Subject: AP1000 Response to Proposed Open Item (Chapter 8)

Subject: AP1000 Response to Request for Additional Information (SRP 3)

RAI Response Number: RAI-SRP3.8.2-CIB1-01
Revision: 4

DRAFT RAI-SRP3.8.2-CIB1-01, Revision 4, "Containment Min. Metal Service Temperature"

Figure 1: Inadvertent Fan Cooler Case at T = -40 F

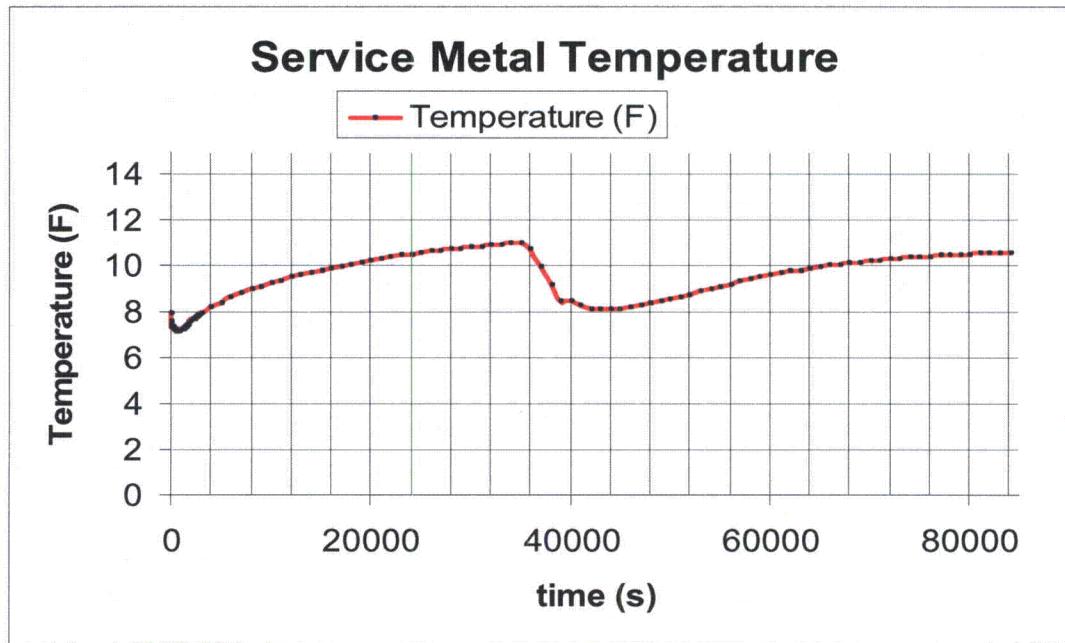
- 1) Please provide a plot of the containment shell temperature response in cold conditions discussed in the RAI response, similar to Figure E-1 provided in response to RAI-SRP-6.2.1.1-SPCV-07 (e). This plot covers the part of the transient used to establish steady-state initial conditions
- 2) Is the minimum service metal temperature of -18.5 °F in the AP1000 DCD based on the steady state result or the additional transient scenario discussed in your response to RAI-SRP-6.2.1.1-SPCV-07?

1. There is one transient type that challenges the minimum service metal temperature requirement of -18.5 F. These transients are an inadvertent actuation of the active containment cooling system (VCS). These transients are discussed in depth in RAI-TR09-008. Figure 1 depicts the inadvertent fan cooler operation case at the minimum safety analysis temperature of -40°F, and an additional case at -30 °F. The WGOTHIC computer code was used to analyze these transients. Figure1 shows the minimum service metal temperature for the inadvertent fan cooler case. The transient was completely contained in one case. The case was allowed to equilibrate for 35000s before transient initiation. Operator action is assumed to occur within 60 minutes to shut off the fan coolers and return the transient to normal conditions. Figure 2 depicts the inadvertent fan cooler case at -30°F. This case is evaluated for containment shell temperature because wind speed at -30°F ambient condition is recorded to be faster than at -40°F resulting in a higher velocity through the annulus between the containment and air baffle and therefore greater heat transfer. The increased heat transfer results in a lower shell temperature. For Figures 1 and 2 the minimum service metal temperature is 7.18°F for the -40°F case and -0.61°F for the -30°F case. The transient cases along with the entire spectrum of analyses considering the external pressure and minimum service metal temperature can be found in APP-MV50-Z0C-039 Rev. 0.

Figure 2: Inadvertent Fan Cooler Case at T= -30 F

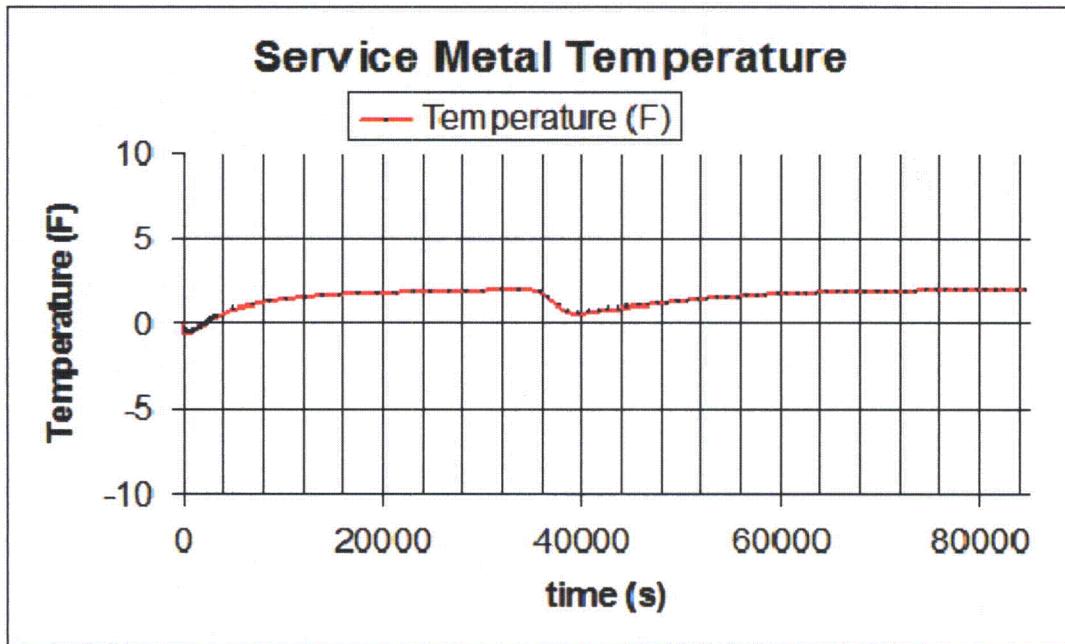
Since temperatures between -40 °F -30 °F, -20 °F, etc. were not used, and a sensitivity study was not performed to show that other temperatures with a higher associated wind speed would not produce a lower calculated minimum service metal temperature, the minimum service metal temperature calculated in Westinghouse Document APP-MV50-ZOC-039, Revision 0 is not bounding. Therefore, in order to complete our evaluation of this issue, we require that WEC either:

Figure 3: Containment Pressure for LOAC transient at -40 F and 25 ft/s.

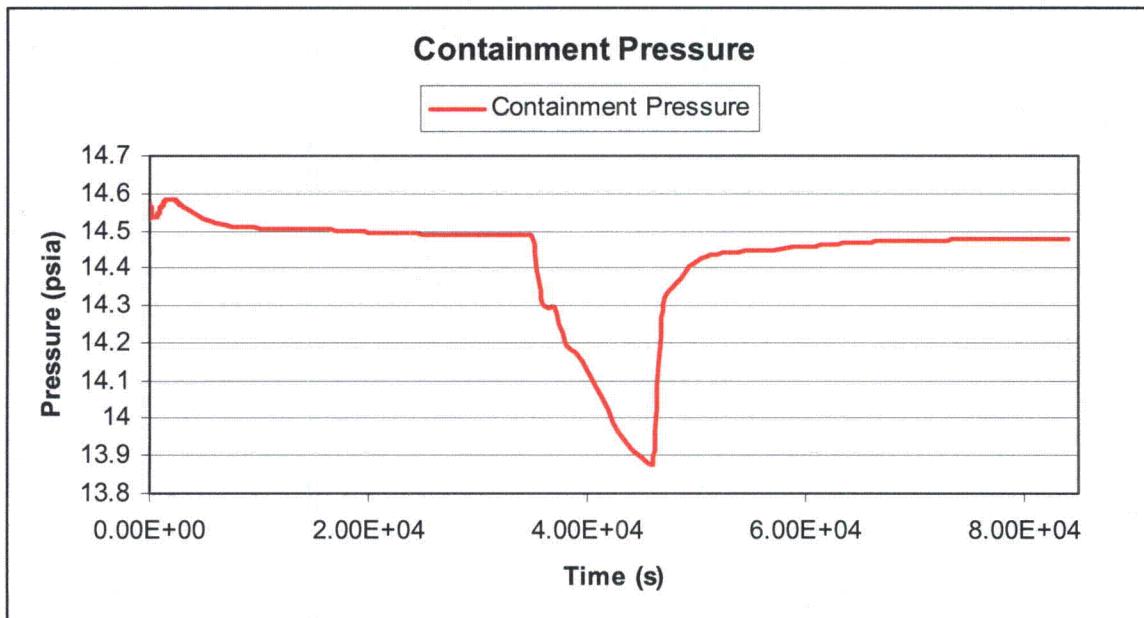
- a. perform a bounding calculation using an outside temperature of -40 °F and a maximum wind speed of 48 mph, used in previous calculations, or provide the following information:

1. To facilitate the staff's closure of this RAI, a bounding case was analyzed to provide an indication of the margin to acceptance criteria associated with the minimum allowable service metal temperature for the AP1000 Containment Vessel. From APP-MV50-Z0C-039 Rev. 0, the LOAC transient (Case 11) at -40°F yielded the lowest service metal temperature of 7.32 °F (Note this was the lowest service metal temperature for the -40 °F transients). For this reason, Case 11 was used as a representative transient to develop a bounding scenario to demonstrate the associated margin to acceptance criteria.

The wind speed for Case 11 was adjusted to achieve 25 ft/s, which corresponds to a 48 mph outside wind speed. The outlet pressure of Boundary Condition (BC) 1 of the Case 11 WGOTHIC base deck was changed to 14.37 psia, to adjust the ΔP magnitude to achieve the 25 ft/s riser velocity. The heat transfer coefficient was recalculated according to the increased velocity in the riser region, and is depicted in Table 1 along with the associated thermophysical properties of air at -40 °F. The HTC was calculated according to the same methodology (application of Dittus-Boelter for turbulent flow in a fluid channel) contained in APP-MV50-Z0C-039 Rev. 0. Figure 3 shows the containment pressure response. It is slightly greater in magnitude (~0.25 psid) than that depicted for Case 11 from APP-SSAR-GSC-039 Rev. 0, but is still within the -0.9 psid constraint.

Figure 6: Elevation of Air Baffle and External Stiffener in relation to TC230 span

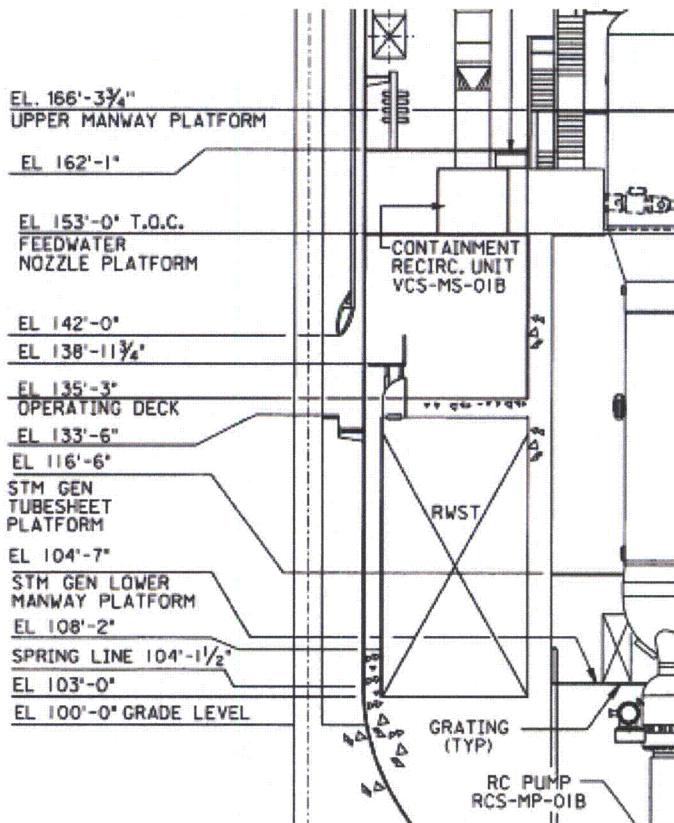
4. Westinghouse Document APP-MV50-ZOC-039, Revision 0 states that the minimum service metal temperature is calculated at TC230 level. Confirm that this location is near the bottom of the air baffle plate, and provide the elevation as shown in Figure 3.8.4-1 of the DCD.

4. From the WGOTHIC model, TC230 spans control volume (CV) 49 from the 135.25' elevation to the 153.0' elevation. From Figure 6, below it is seen that the 135.25' elevation is below the bottom of the air baffle plate, and the upper elevation of 153.0' is above the air baffle plate, so TC230 spans the region just above the external stiffener to above the bottom of the air baffle plate which is at the 142.0' elevation.
